RE: Docket No. 99-6550, Notice of Proposed Rulemaking  
FMVSS 105 & 121 Heavy Vehicle Antilock Brake System (ABS)  
Performance Requirement

Mitsubishi Motors Comments to Notice of Proposed Rulemaking  
FMVSS 105 & 121 Heavy Vehicle Antilock Brake System (ABS)  
Performance Requirement  
(Docket No. 99-6550)

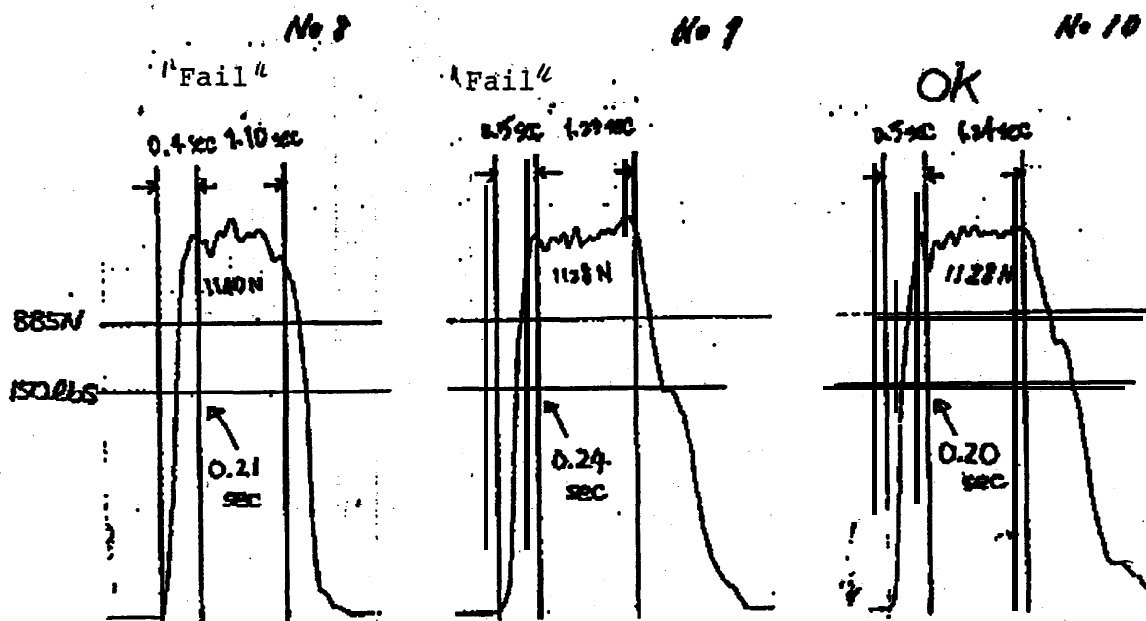
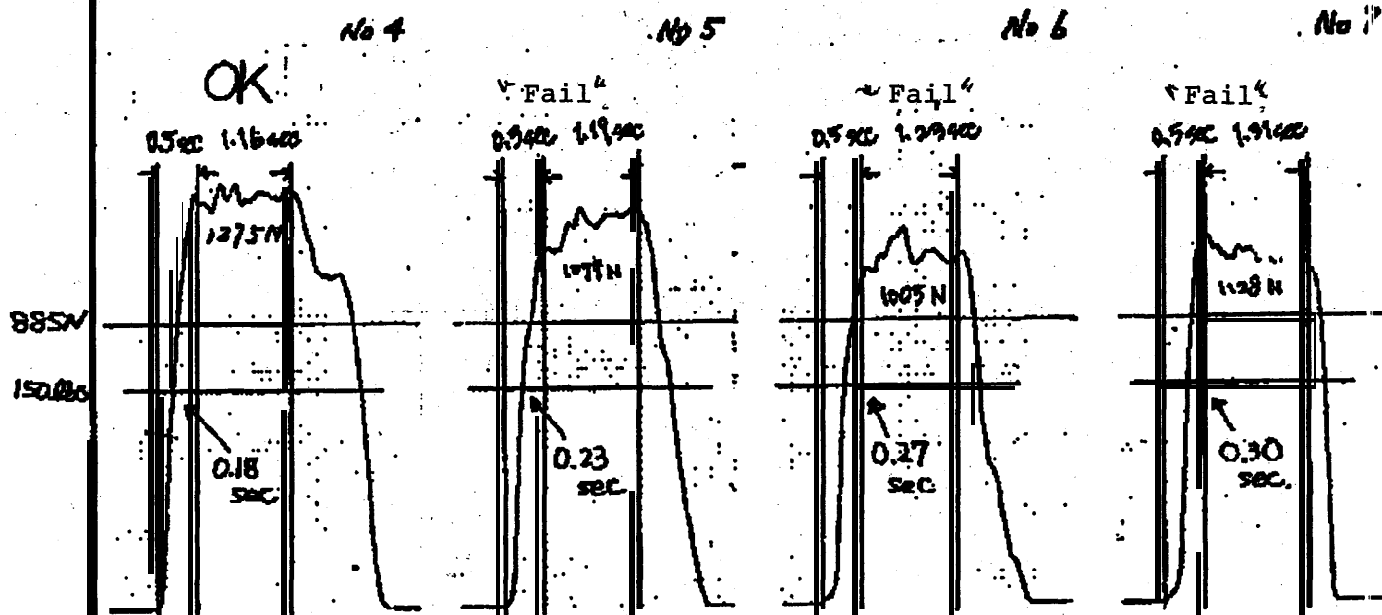
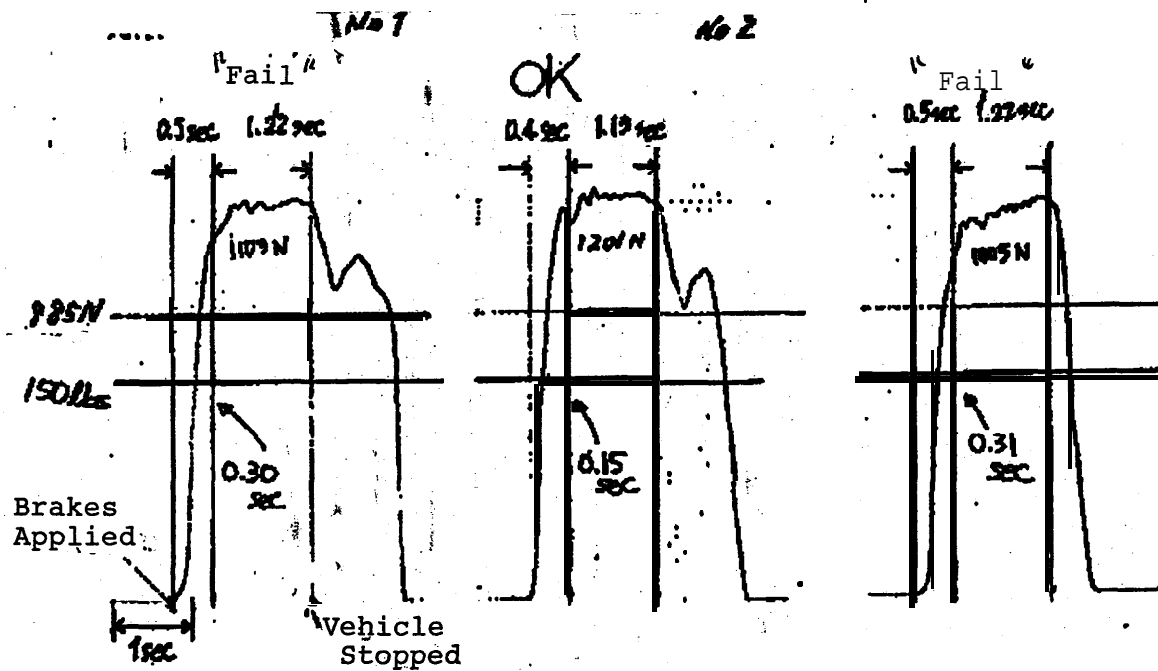
Mitsubishi Motors wishes to point out that in the proposed language of S7 of FMVSS 105, which states; "For vehicles only having to meet the requirements of S5.1.1, S5.1.2 S5.1.3, and S5.1.7 in section S5.1, the applicable test procedures and sequence are S7.1, S7.2, S7.4, S7.5, S7.5, S7.9, S7.10, S7.11, and S7.18", appears to be in error. Mitsubishi Motors believes, the underlined S7.11 should be omitted in this section as S7.11 is referenced in the test procedures of S5.1.4 (refer to Table 1 in FMVSS 105) and S5.1.4 is not included in the above-mentioned sections (S5.1.1, S5.1.2, S5.1.3, S5.1.7).

Mitsubishi makes this request on review of spike stop test data conducted for Australian regulations(ADR 35/0), which is being submitted with this comment (see attachments 1 & 2).

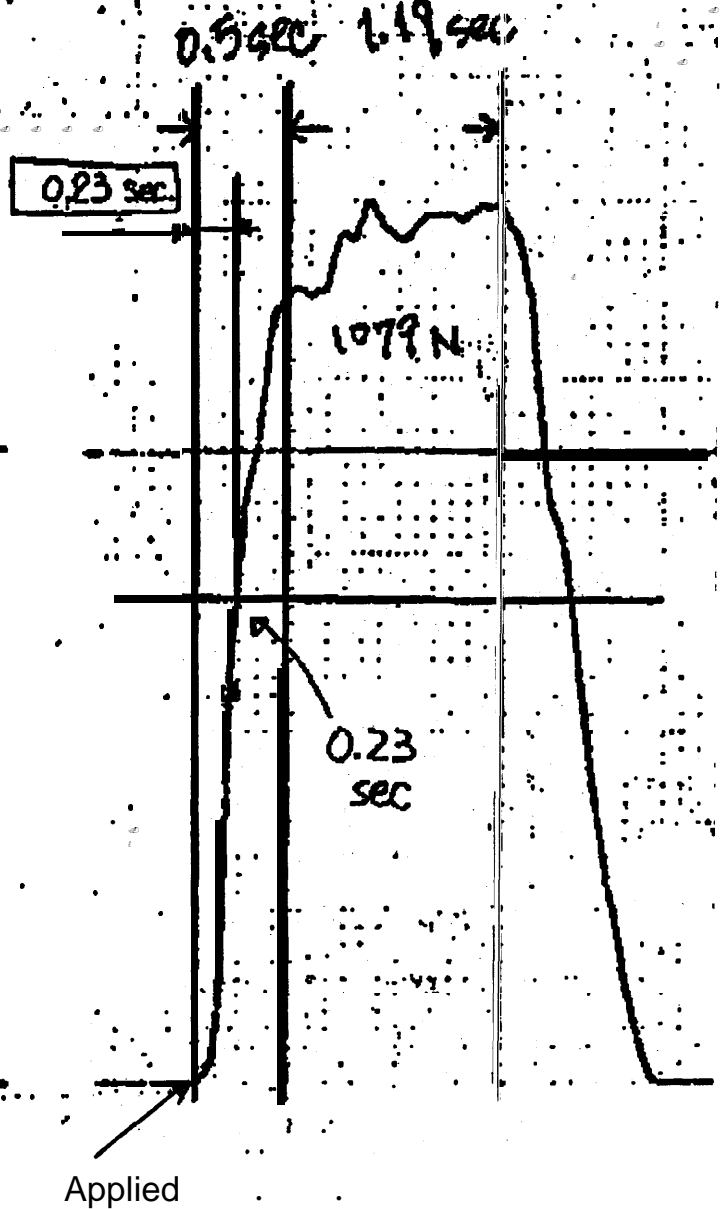
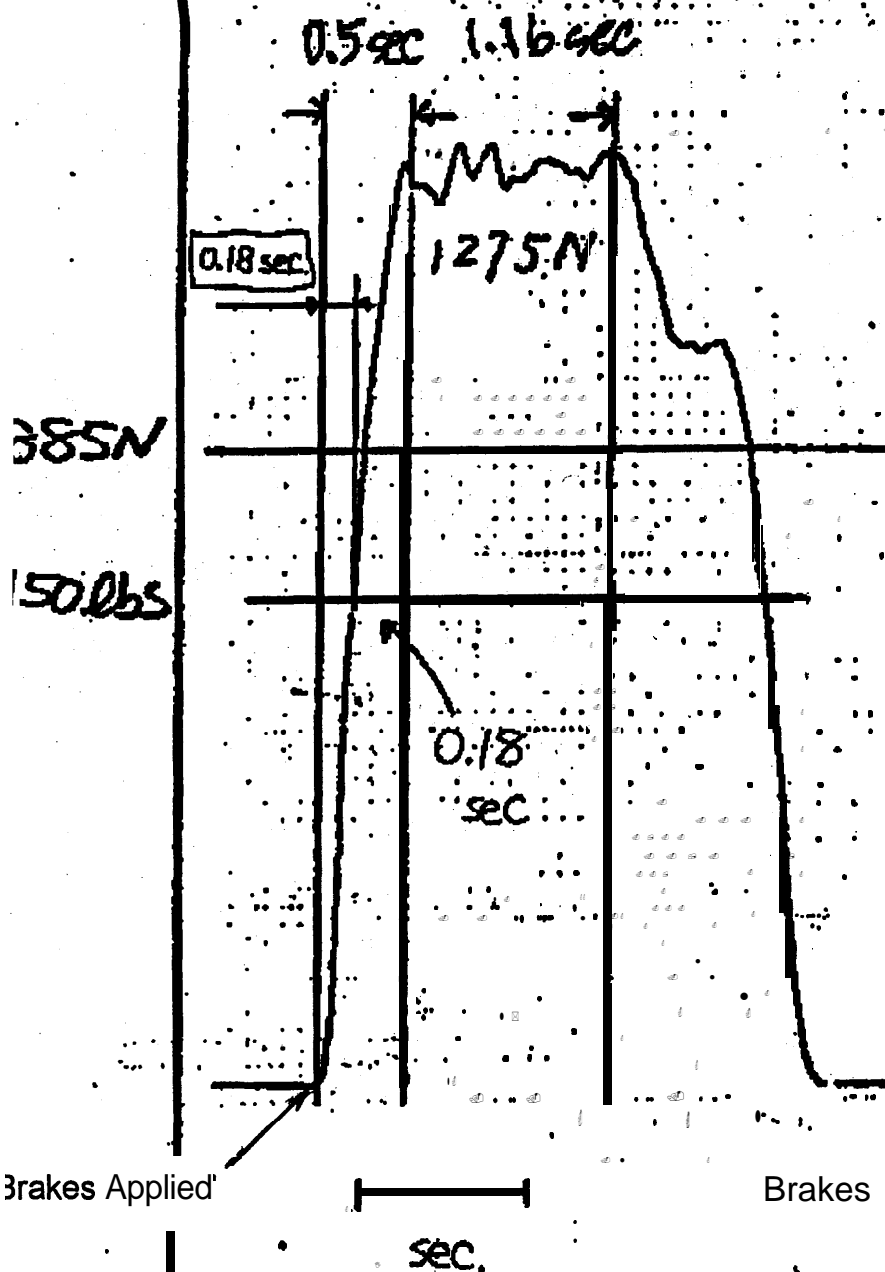
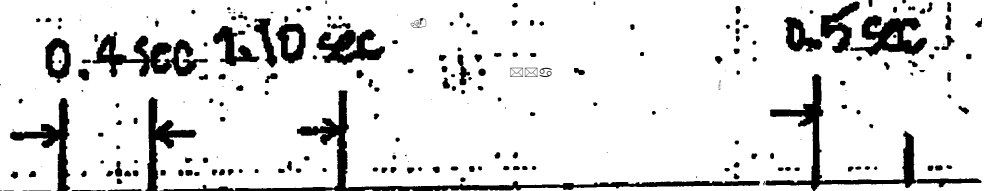
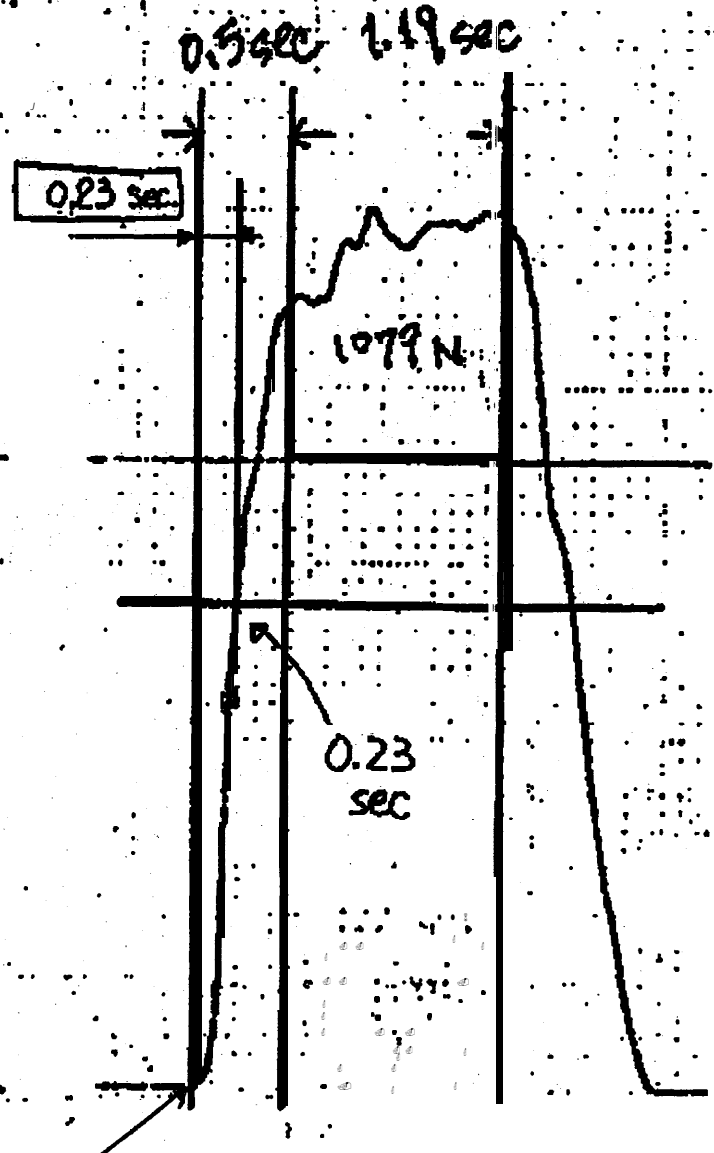
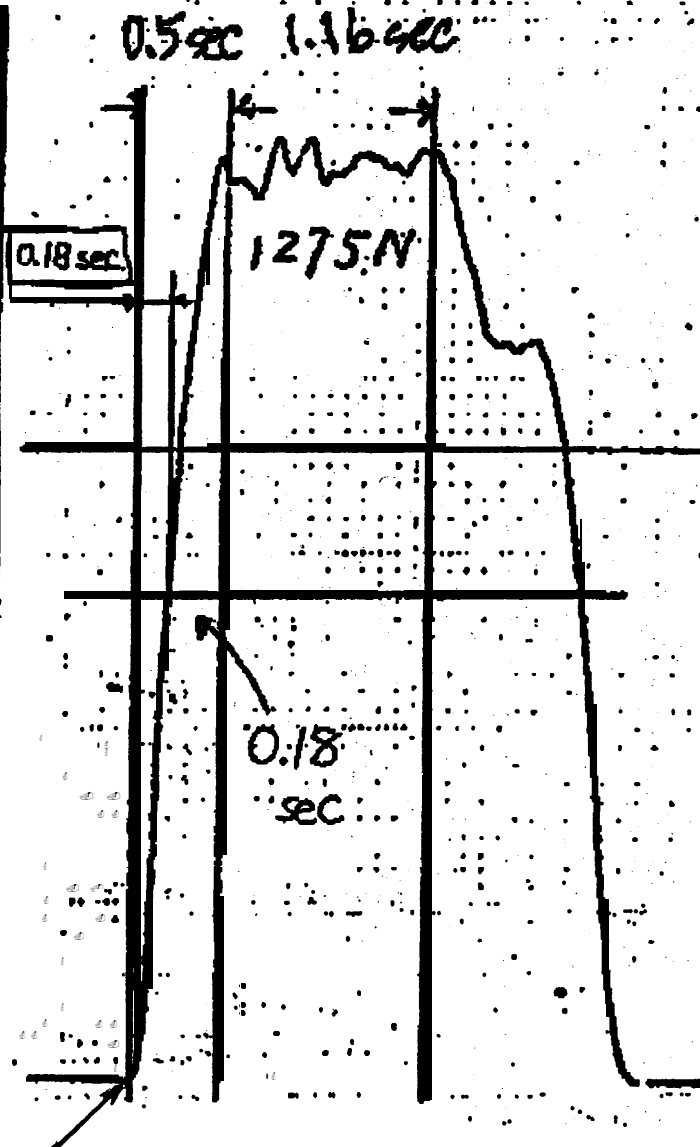
Mitsubishi Motors request that NHTSA amend the definition of "Full Brake Application" in S4 of FMVSS 105, "a brake pedal force of 150 pounds that is to be achieved within 0.2 seconds..", to read; "a brake pedal force of 150 pounds that is to be achieved within **0.5 seconds**".

As the data shows, a 150 lb. (68 kg) brake application force at 0.2 seconds was achieved only in three out of ten stops. Given this, Mitsubishi Motors believes that the proposed "... within 0.2 seconds" requirement is impracticable.

Based on the same data, Mitsubishi Motors does believe a 150 lb. (68 kg) brake application force at 0.5 seconds is more practicable value.
